ADDENDUM NO. 4

May 19, 2022

**LIBERTY INTERMEDIATE SCHOOL ADDITIONS
AND RENOVATIONS
Chesterton, IN 46304**

This Addendum consists of Pages ADD 4-1 through ADD 4-4 and attached Addendum No. 4 from Gibraltar Design dated May 18, 2022 and consisting of 4 pages and 47 drawings.

C-2.0

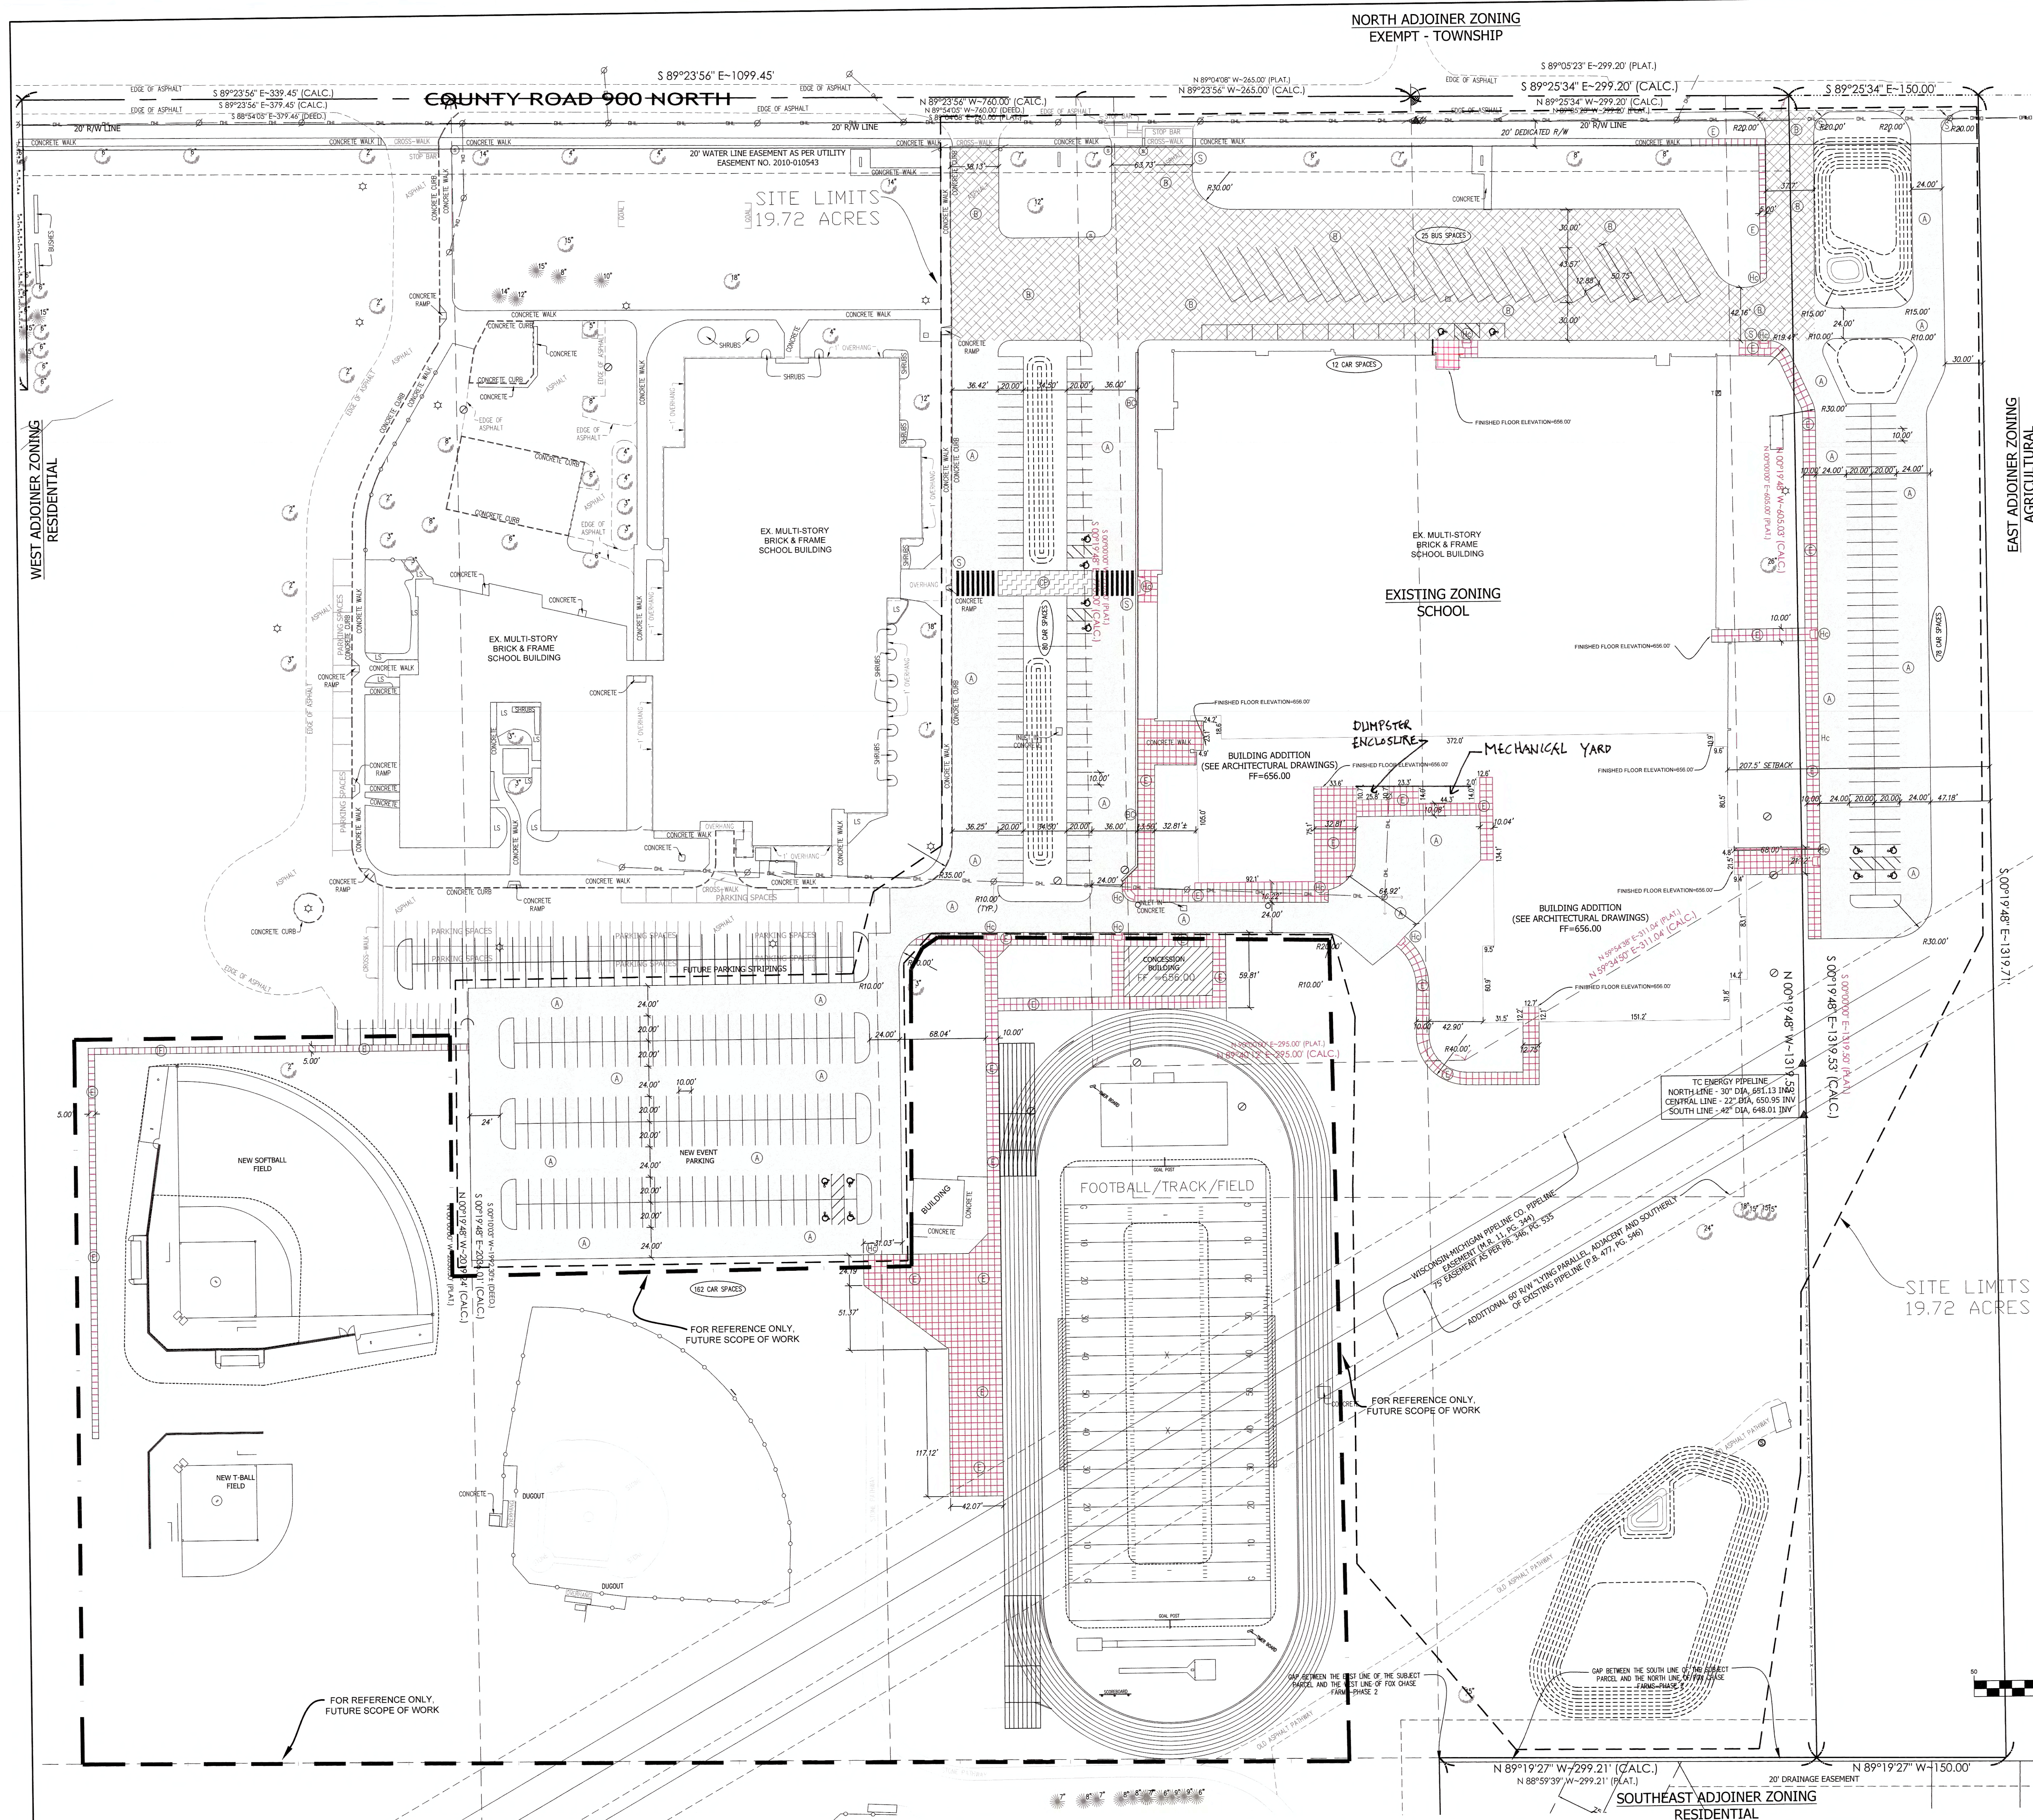
- 2. Sheet G-201**
 - A. Refer to revised full-size drawing included in this Addendum, for revisions.
- 3. Sheets C-2.0, C-3.0, C-3.1, C-4.0**
 - A. Refer to Four (4) revised full-size drawings included in this Addendum, for revisions.
- 4. Sheets S-102, S-104, S-105**
 - A. Refer to Three (3) revised full-size drawings, included in this Addendum, for revisions.
- 5. Sheets S-200, S-202, S-203, S-204**
 - A. Refer to Four (4) revised full-size drawings, included in this Addendum, for revisions.
- 6. Sheets S-403, S-415**
 - A. Refer to Two (2) revised full-size drawings, included in this Addendum, for revisions.
- 7. Sheet AD101, AD105, AD106**
 - A. Refer to Three (3) revised full-size drawing included in this Addendum, for revisions.
- 8. Sheets A-105 and A-108**
 - A. Refer to Two (2) revised full-size drawings included in this Addendum, for revisions.

A-610

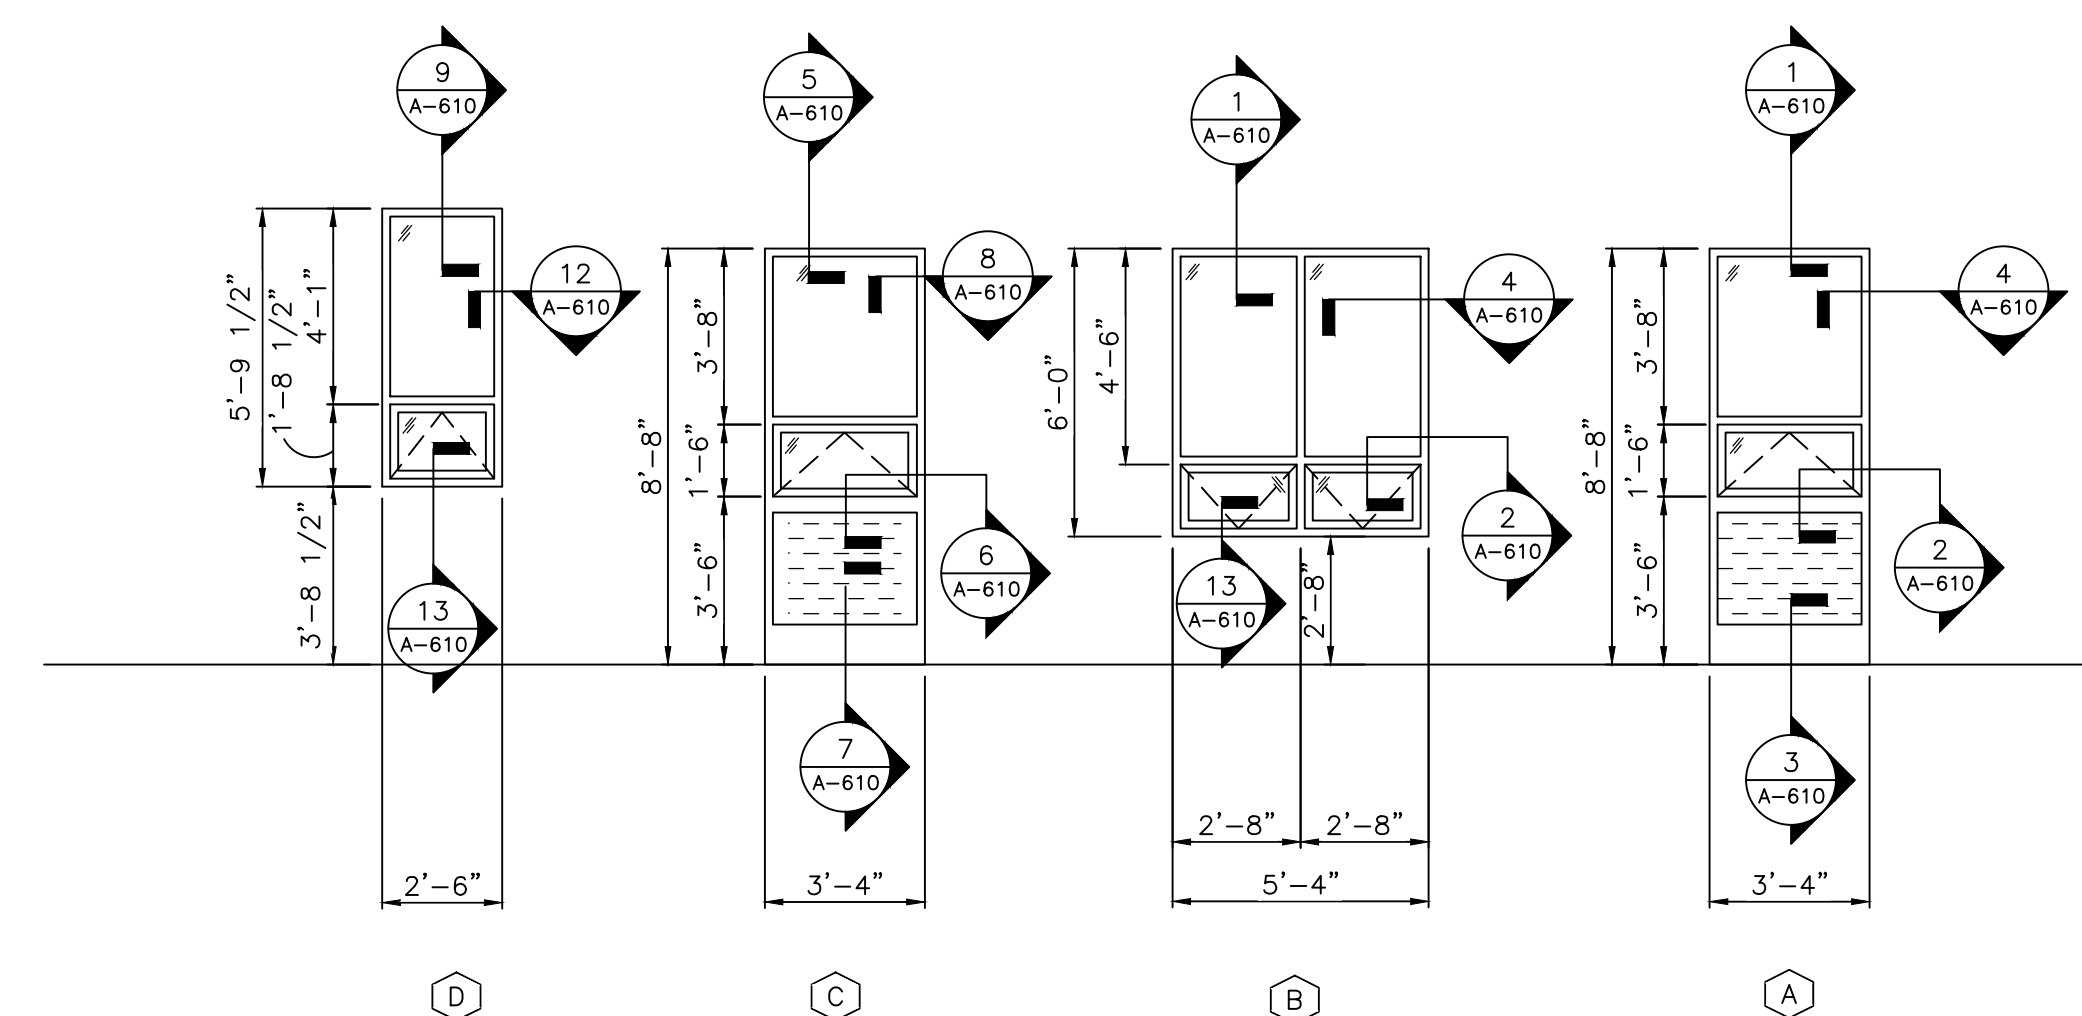
A. Refer to revised full-size drawing included in this Addendum, for revisions.

E-002

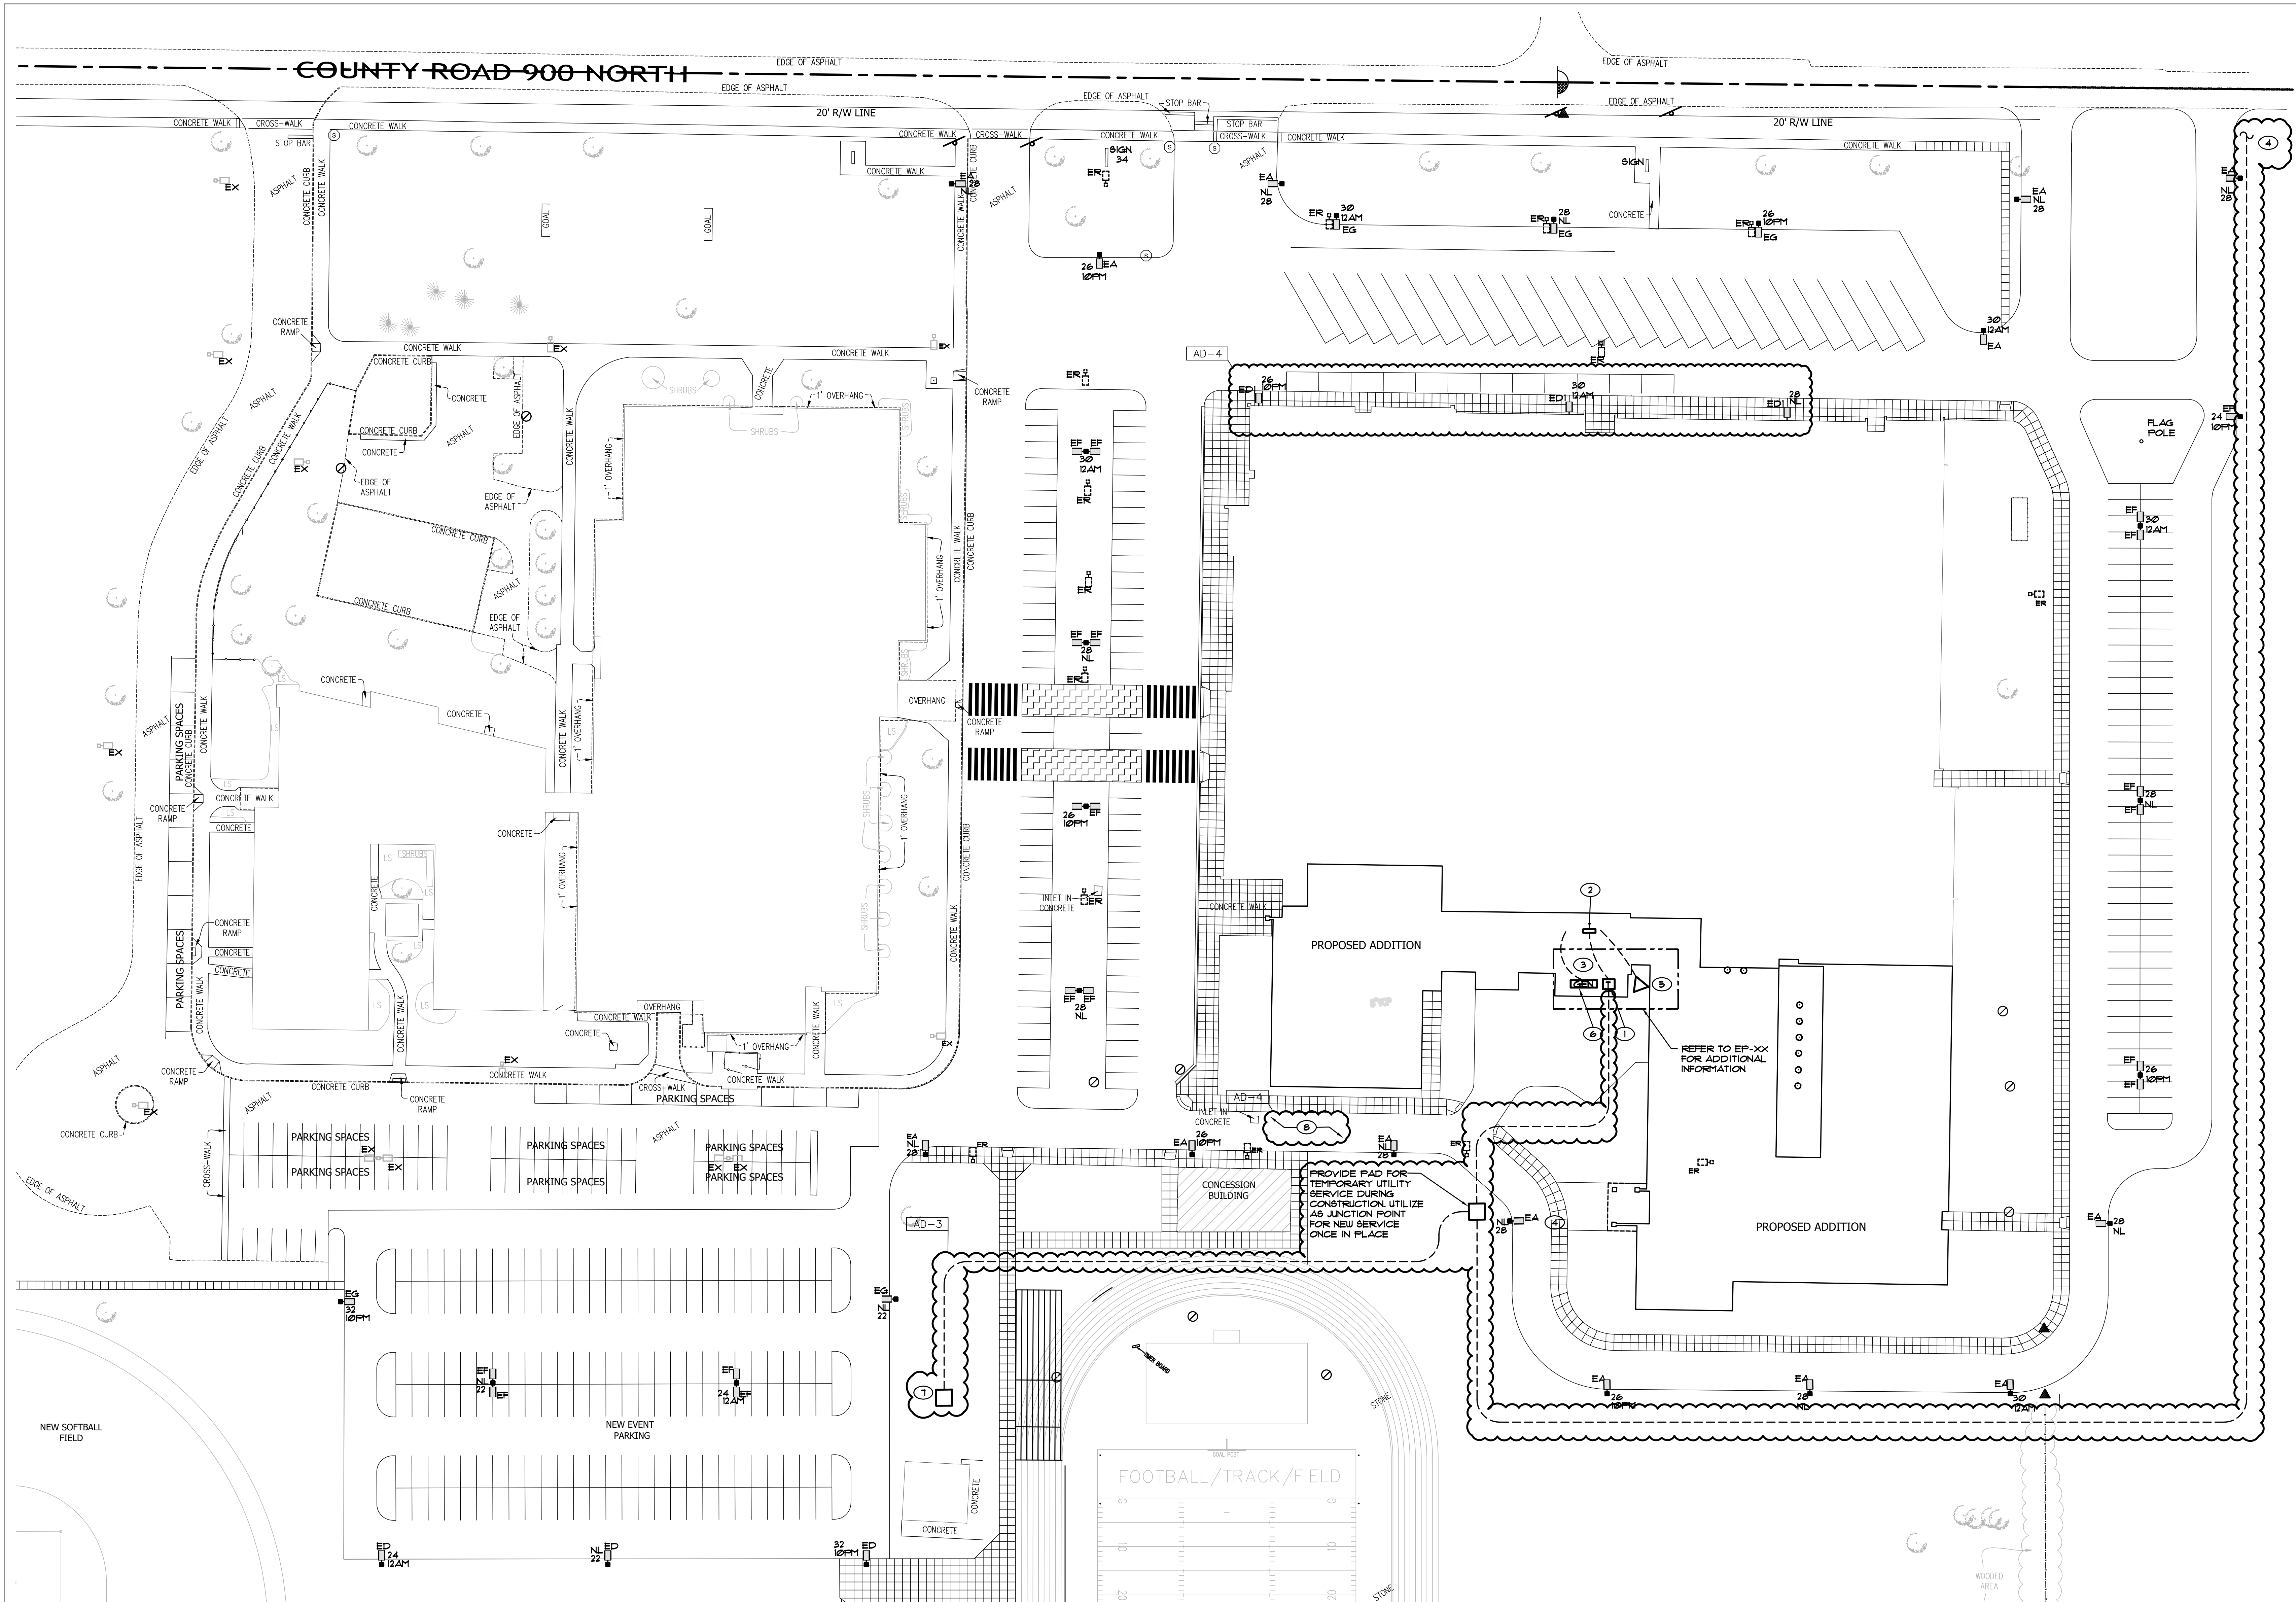
A. Refer to revised full-size drawing included in this Addendum, for the following revisions:

1. Revised north parking lot site poles to wall mounted lights at 12'. Identify fixture with ED1 tag.
2. Add note to include removal of (4) existing power poles.
